SERVICE BULLETIN

N° **139-729**

ATA 28 – FUEL PORT MODIFICATION

AW139 helicopters from S/N 41801 to S/N 41804.

Figure 1

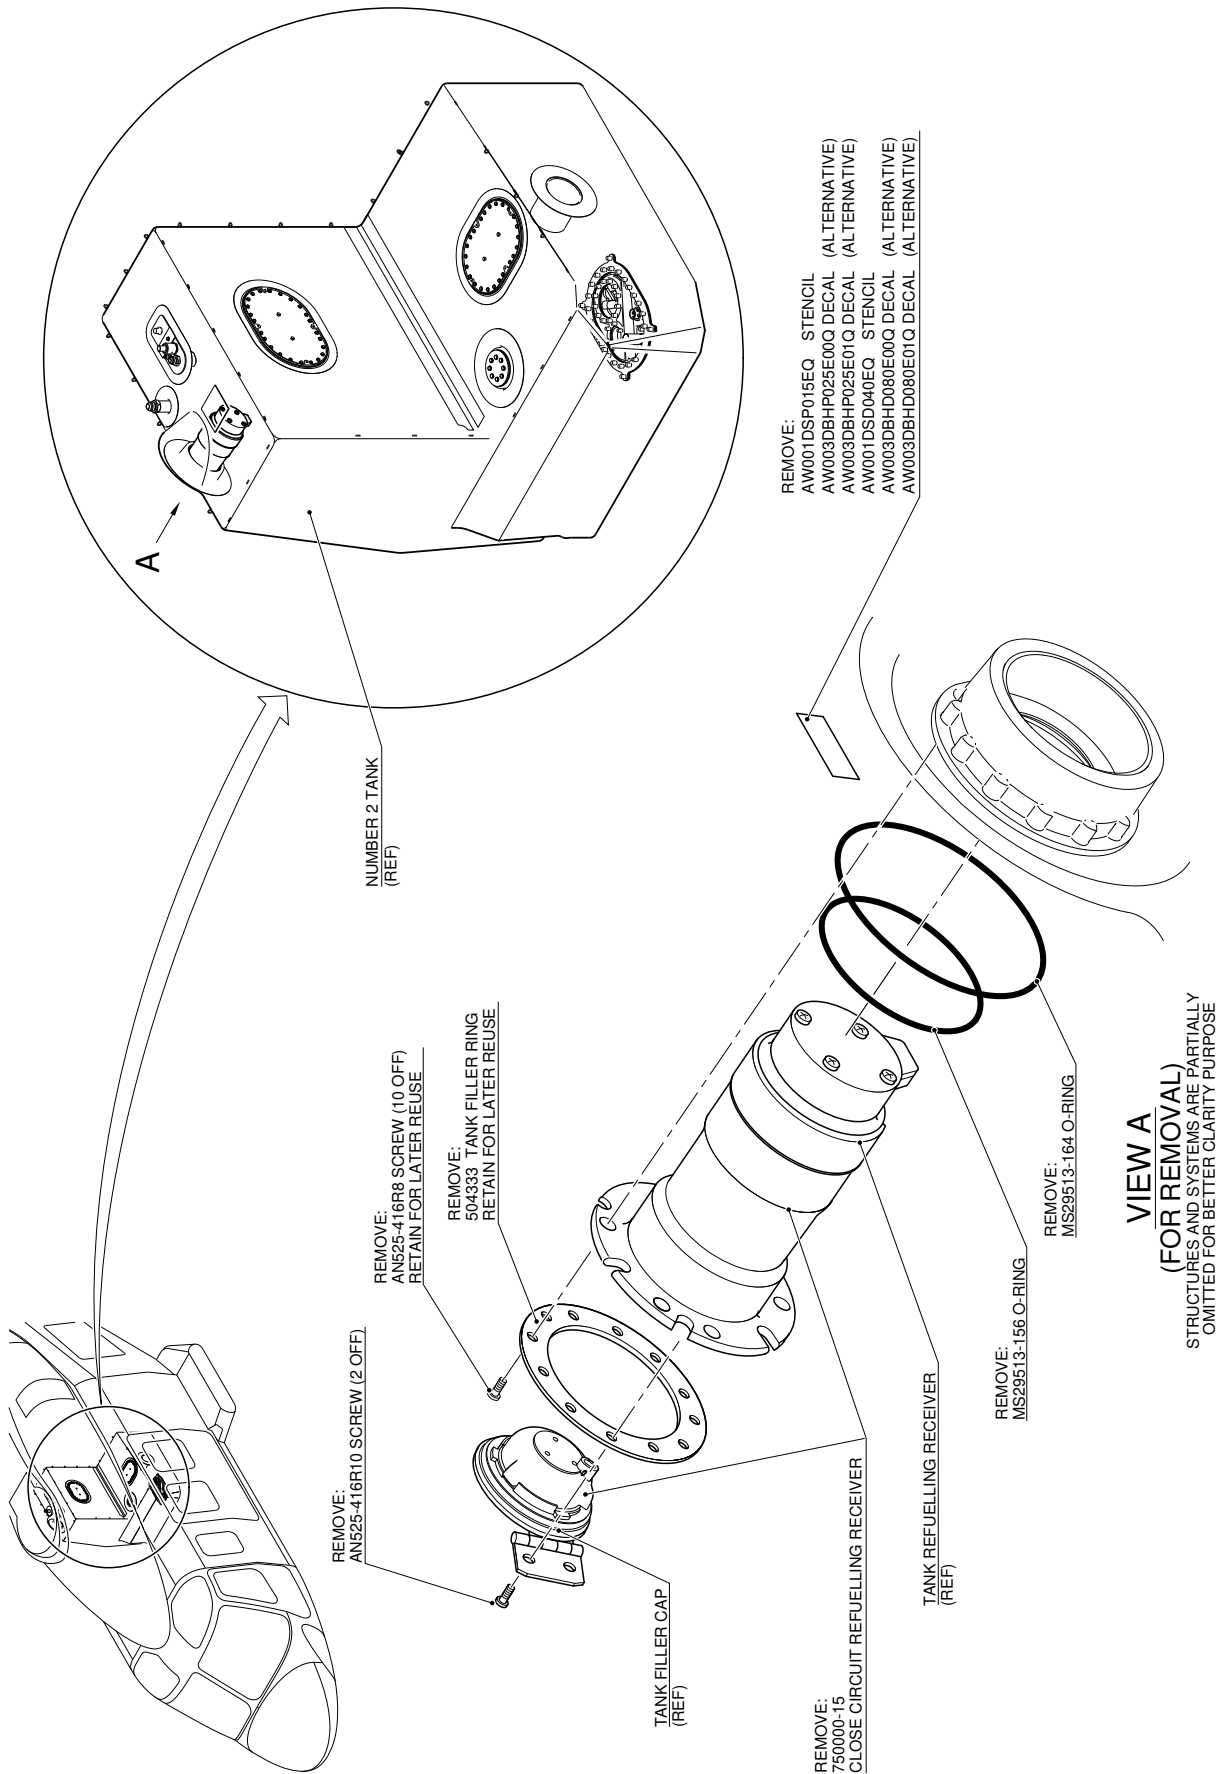
2. With reference to Figure 1, perform the removal of kit close circuit refuelling receiver P/N 4G2820F00111 as described in the following procedure:
 - 2.1 In accordance with AMP DM 39-A-28-11-03-00B-520A-K and with reference to Figure 1 View A, remove the tank filler cap (part of close circuit refuelling receiver P/N 750000-15) and n°2 screws P/N AN525-416R10.
 - 2.2 In accordance with AMP DM 39-A-28-11-04-00B-520A-K and with reference to

- Figure 1 View A, remove the tank filler ring P/N 504333 and n°10 screws P/N AN525-416R8. Retain the tank filler ring and the screws for later reuse.
- 2.3 In accordance with AMP DM 39-A-28-11-19-00B-520A-K and with reference to Figure 1 View A, remove the tank refuelling receiver (part of close circuit refuelling receiver P/N 750000-15), the O-ring P/N MS29513-156 and the O-ring P/N MS29513-164. Discard the O-rings.

- 2.4 With reference to Figure 1 View A, remove and discard the stencil P/N AW001DSP015EQ or the decal P/N AW003DBHP025E00Q or the decal P/N AW003DBHP025E01Q.

- 2.5 With reference to Figure 1 View A, remove and discard the stencil P/N AW001DSD040EQ or the decal P/N AW003DBHD080E00Q or the decal P/N AW003DBHD080E01Q.

Figure 2

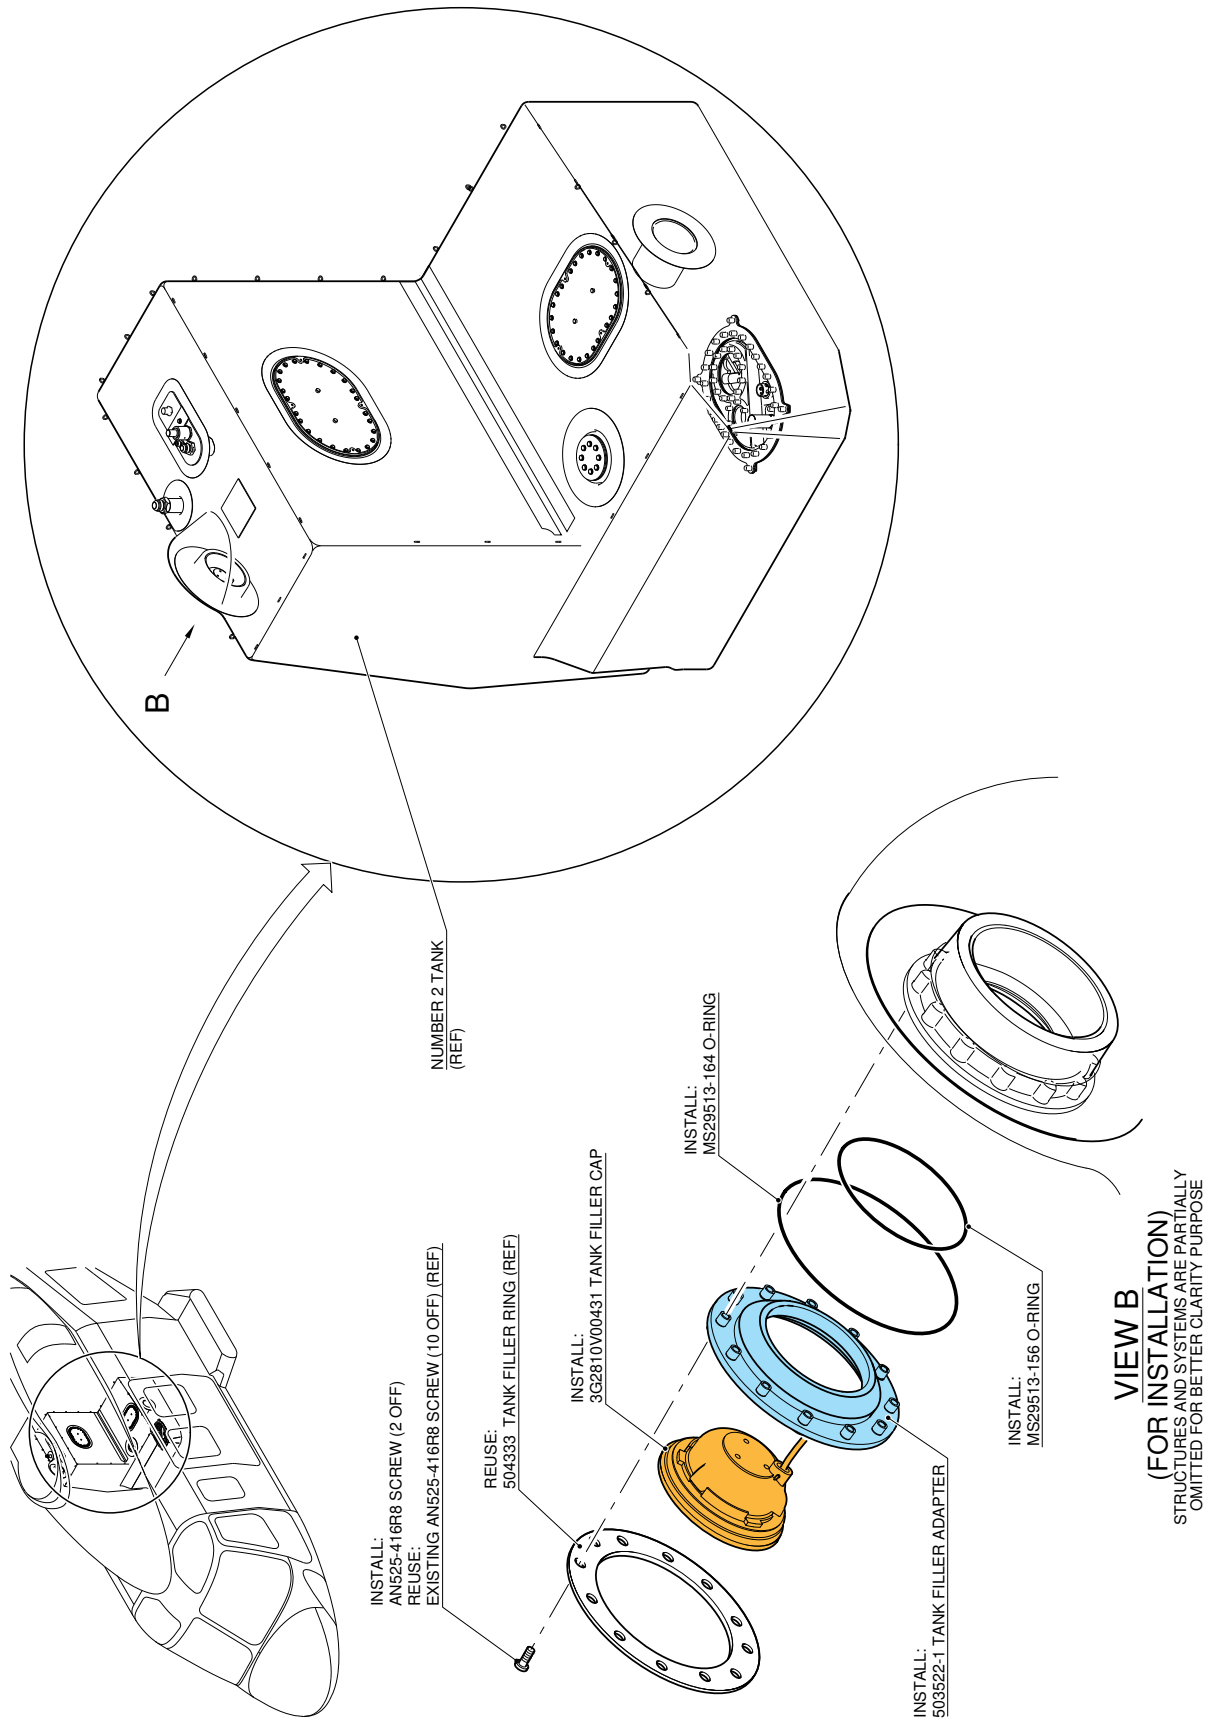
3. In accordance with AMP DM 39-A-28-11-19-00A-720A-A and with reference to Figures 2 View B, install the tank filler adapter P/N 503522-1, the O-ring P/N MS29513-156 and the O-ring P/N MS29513-164.

4. In accordance with AMP DM 39-A-28-11-04-00A-720A-A and with reference to Figures 2 View B, re-install the tank filler ring P/N 504333 by means of n°12 screws P/N AN525-416R8.

5. In accordance with AMP DM 39-A-28-11-03-00A-720A-A and with reference to Figures 2 View B, install the tank filler cap P/N 3G2810V00431.
 6. In accordance with weight and balance changes, update the Chart A (see Rotorcraft Flight Manual, Part II, section 6).

Figure 4

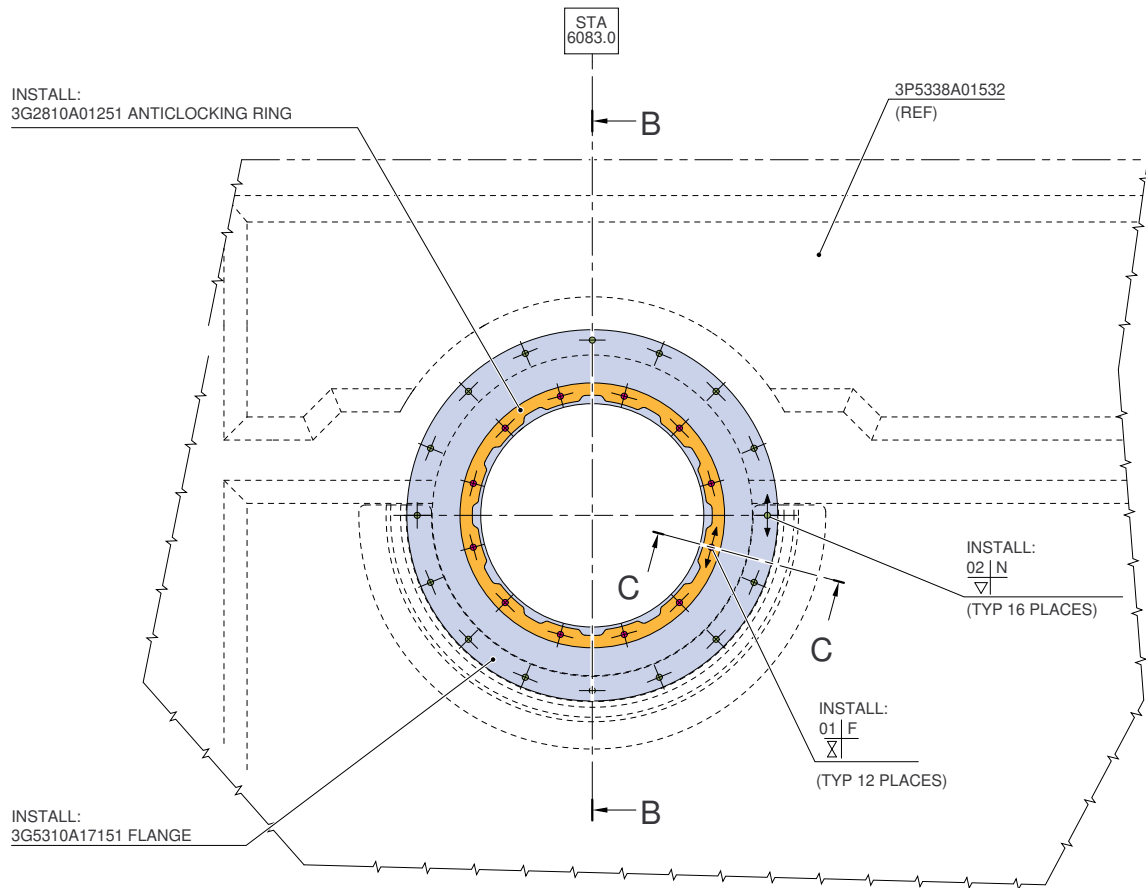
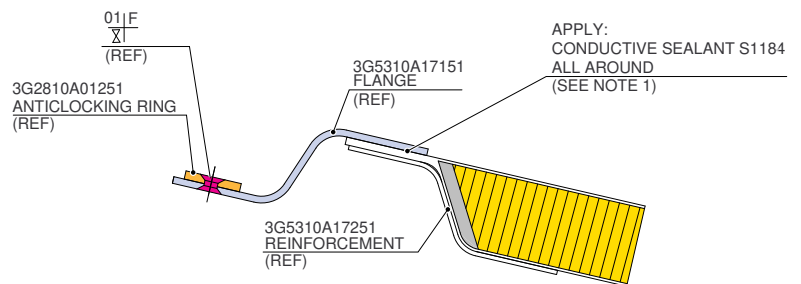
- the upper plate P/N 3G5310P04054;
 - the lower plate P/N 3G5310P04053;
 - the additional shim P/N 3G5310P04057;
 - the shim P/N 3G5310P04052.
 - 2.1 With reference to Figure 4 Detail A, install the anticlocking ring P/N 3G2810A01251 by means of n°12 rivets P/N MS20426AD4-6 on the flange P/N°3G5310A17151.

- 2.2 In accordance with AMP DM 39-A-20-10-01-00A-259A-A and with reference to Figure 4 Section C-C, if necessary prepare the indicated contact surfaces to assure the correct electrical bonding.

- 2.3 With reference to Figure 4, install the flange P/N 3G5310A17151 by means of n°16 rivets P/N MS20426AD4-5-5 on the panel P/N 3P5338A01532. Use conductive sealant S1184 all around.

Figure 5

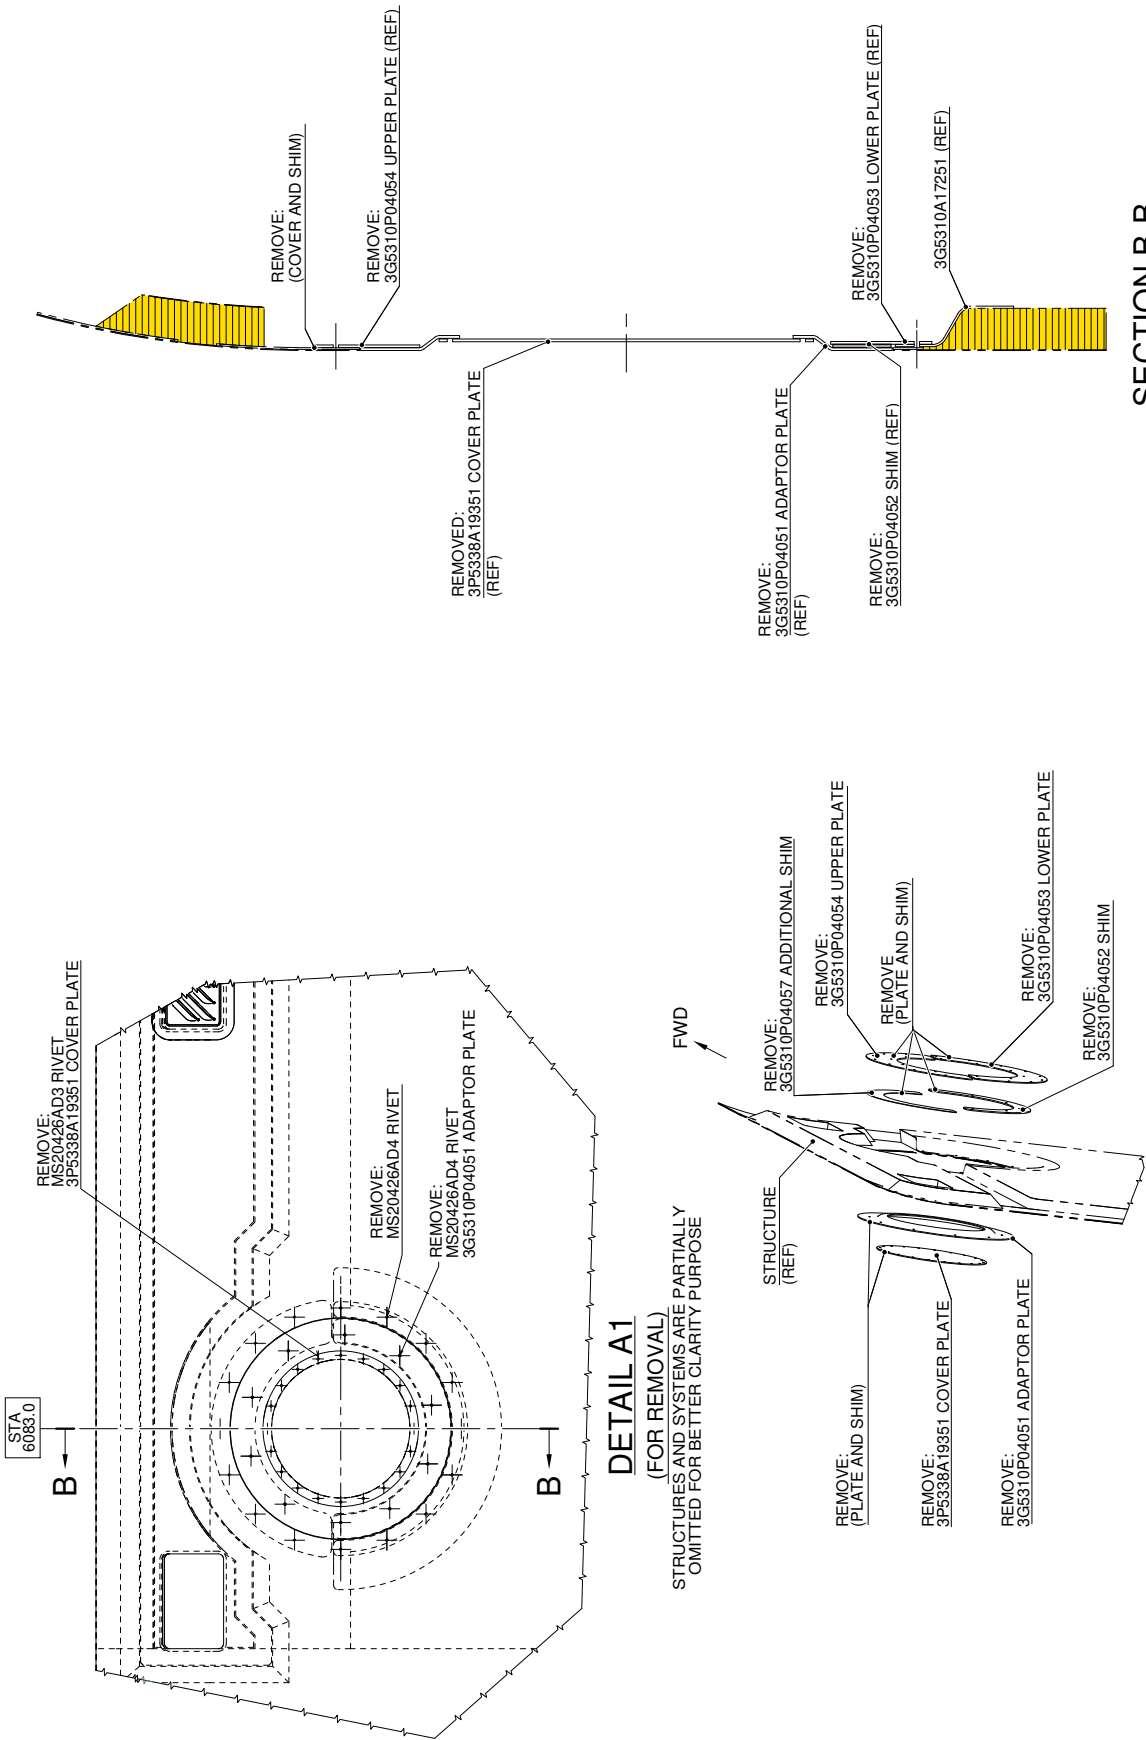
- 2.1 With reference to Figure 5, remove the following components and related fixing hardware:
 - the cover plate P/N 3P5338A19351;
 - the adaptor plate P/N 3P5310P4051;

Figure 6

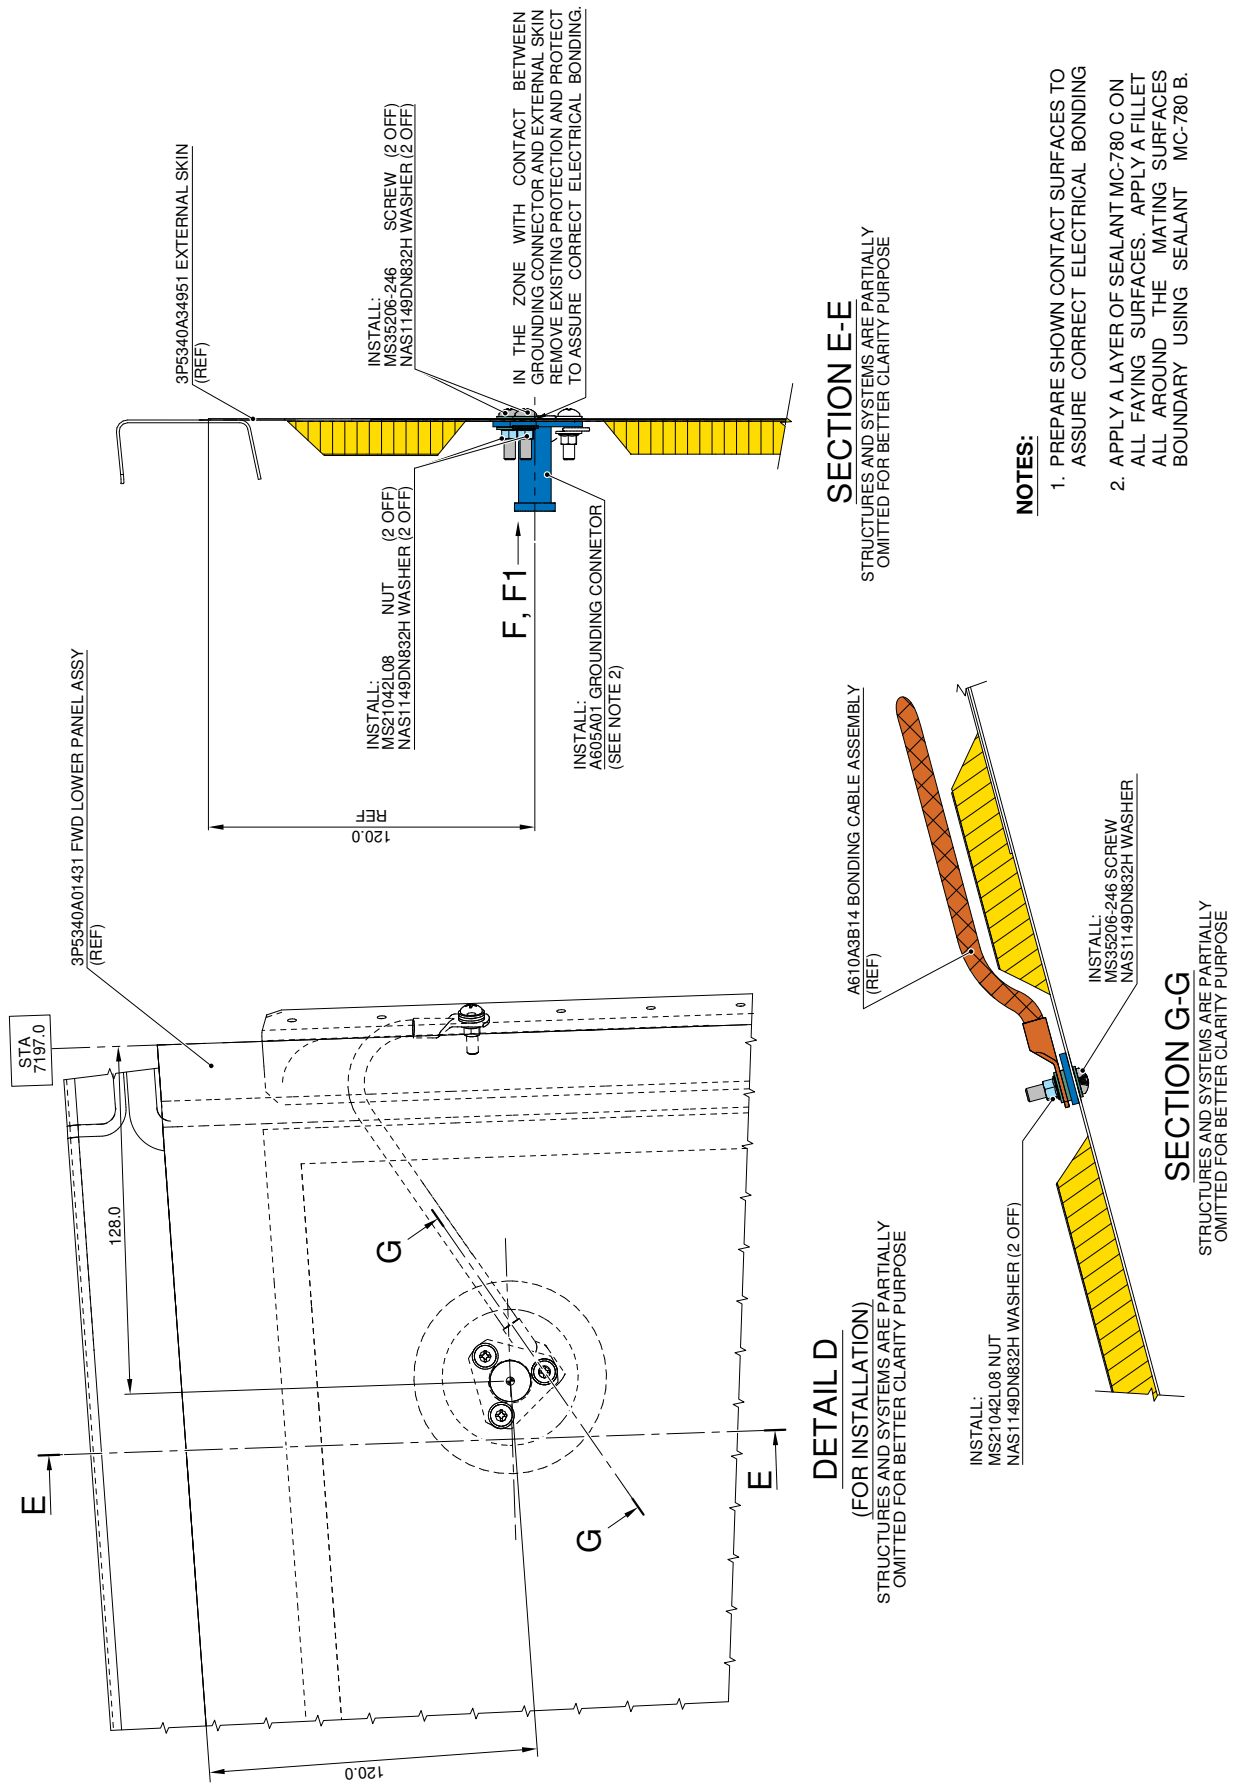
- 2.5 In accordance with AMP DM 39-A-20-10-01-00A-259A-A and with reference to Figure 6 Section E-E, prepare the indicated contact surfaces on the external skin P/N 3P5340A34951 to assure the correct electrical bonding.

- 2.6 With reference to Figure 6 Section E-E, install grounding connector P/N A605A01 by means of n°2 screws P/N MS35206-246, n°4 washers P/N NAS1149DN832H and n°2 nuts P/N MS21042L08.
- 2.7 With reference to Figure 7 Section H-H, remove existing rivets and drill a hole Ø 5.0÷5.2 on the profile STA 7200 P/N 3P5340A12951.
- 2.8 In accordance with AMP DM 39-A-20-10-01-00A-259A-A and with reference to Figure 7 Section H-H, prepare the indicated surfaces on the profile STA 7200 to assure the correct electrical bonding
- 2.9 With reference to Figure 6 Section G-G and Figure 7 Section H-H, install the bonding cable assy P/N A601A3B14 by means of n°2 screws P/N MS35206-246, n°6 washers P/N NAS1149DN832H and n°2 nuts P/N MS21042L08.
